Eskom	Tender Questions and Answers	Document Identifier	240-7124948	Rev	1
		Effective Date	01 April 2023		
		Review Date	April 2026

Request for Enquiry Number	E1250GXPOU
Description / Project Title	ACCESS ROADS MAINTENANCE AT PALMIET PUMPED STORAGE SCHEME
Tender Questions Closing Date	5 days before tender closing

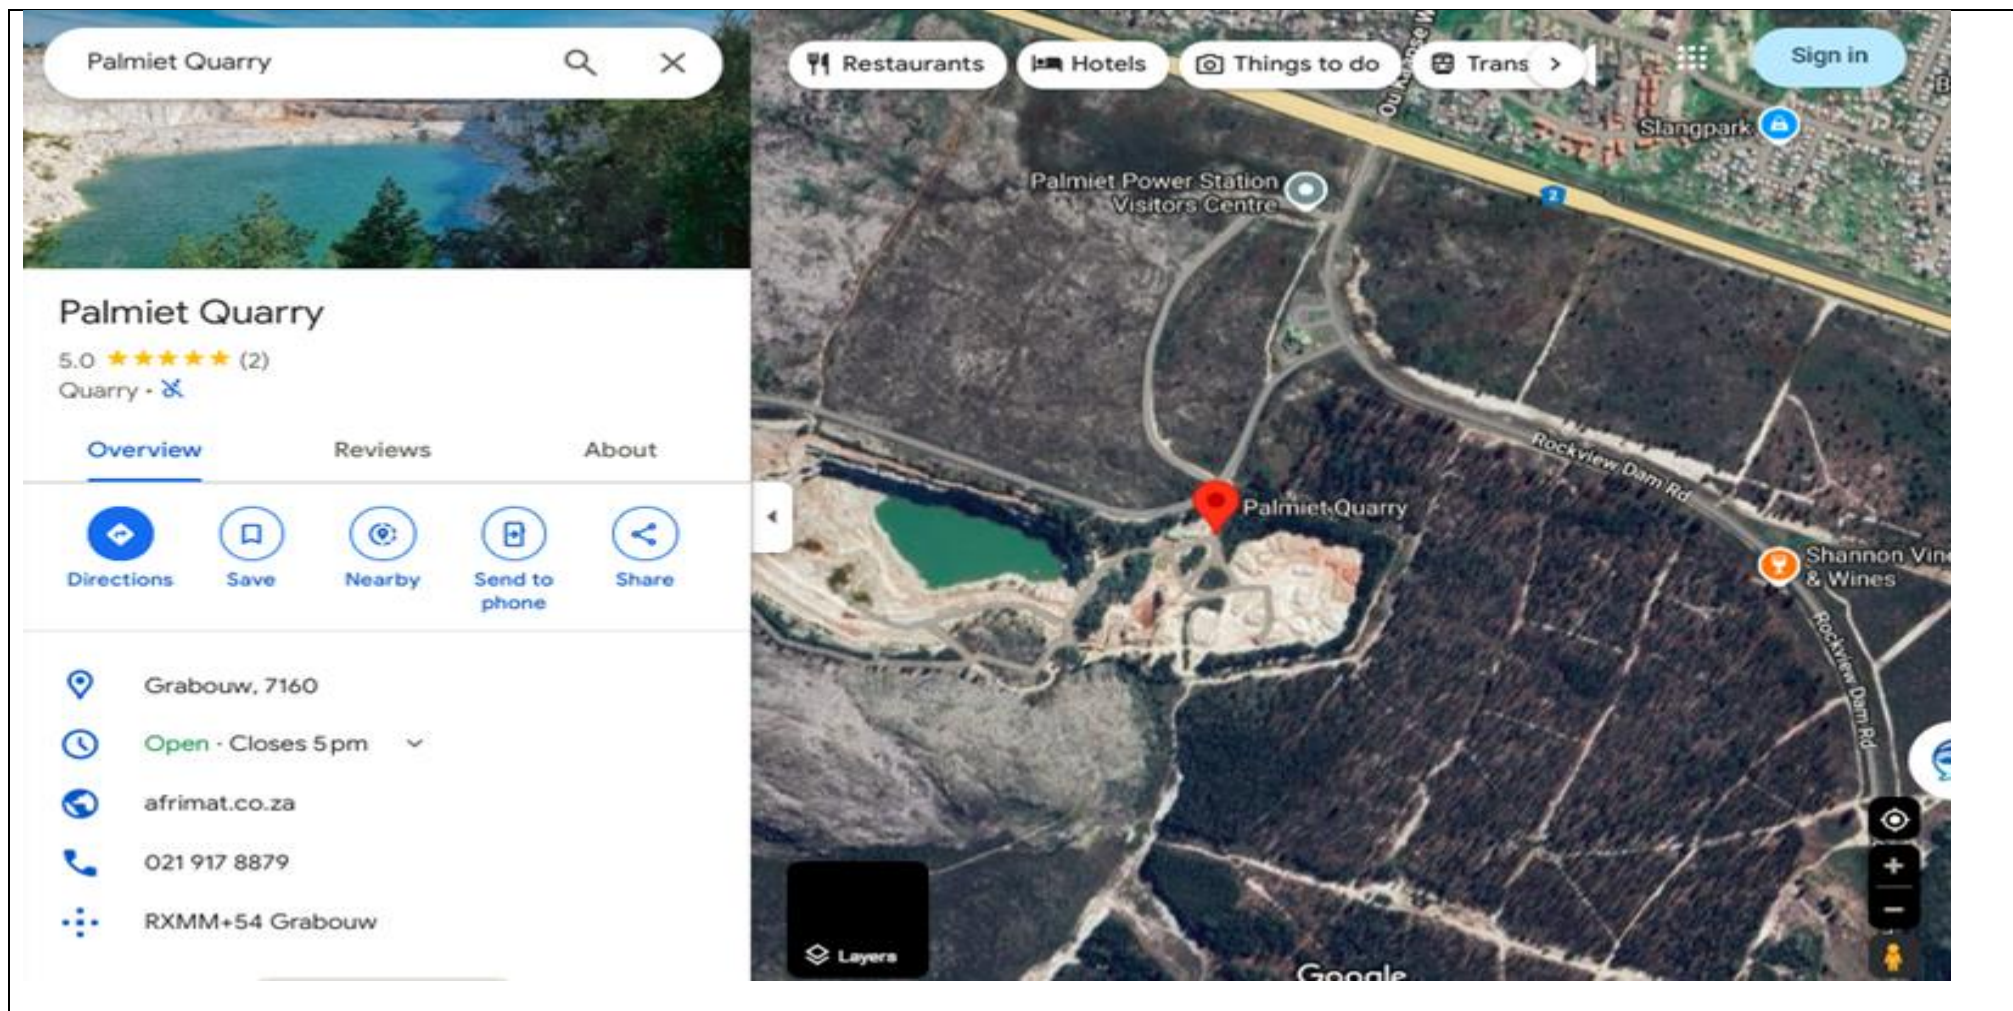
Supplier said in some cases the engineer will instruct you get a commercial, they have to come and do the testing. So how that all work as you'll give the invoice with your 5 or 10% markup, whatever you're prescribing. So it's really just a handing cost, you're only paying for what gets done, basically, yes, because this contractors will be accept. It will only be a handling cost.	Engineering also made mentioned that they included the testing under the specific schedules to make allowance in case it is required.	
12.	Jeep track – Schedule D 20.1.1 – G5 Material to be used due to area being an environmental sensitive area.	There is a Quarry where the G5 Material can be purchased i.e., at Afrimat . Screen-print for contact number and address / map below:	2025/06/02
